Model Name: Ricoh JP5800

Model: PRIPORT RUBY

Modified Article: Paper Guide

Modification Bulletin

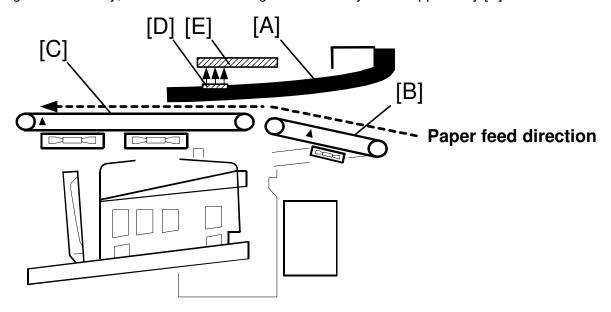
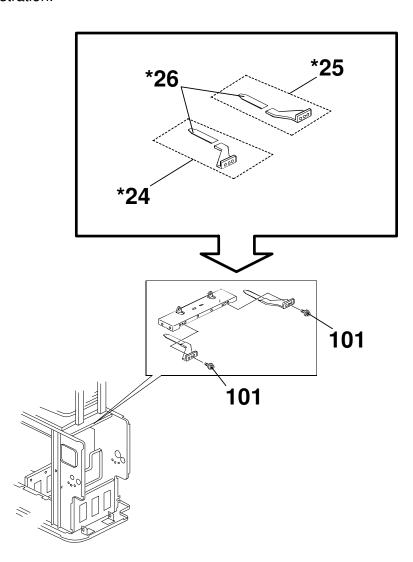
Change: Added front guide assembly [A], rear guide assembly.

Reason: To ensure that curled paper is fed smoothly in the relay transport area [B] and horizontal transport area [C].

Important: When images with many solid image areas are printed out often, light scratches can appear on the copy. For these customers, attach a piece of double-sided tape [D] to the guide assembly, and then attach the guide assembly to the upper stay [E].

Illustrations:

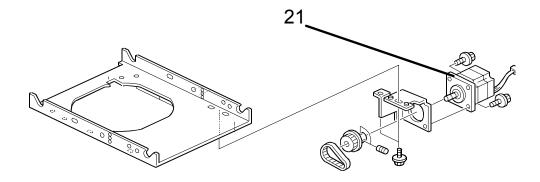
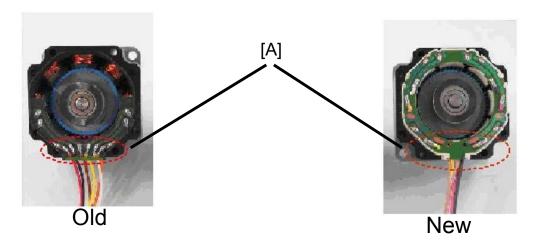
Change: The internal connection of the harness and motor was changed.

Reason: To ensure that the harness stays connected to the motor. This will ensure that a jam at the relay transport unit does not occur.

[A]: Internal connection point of the harness.
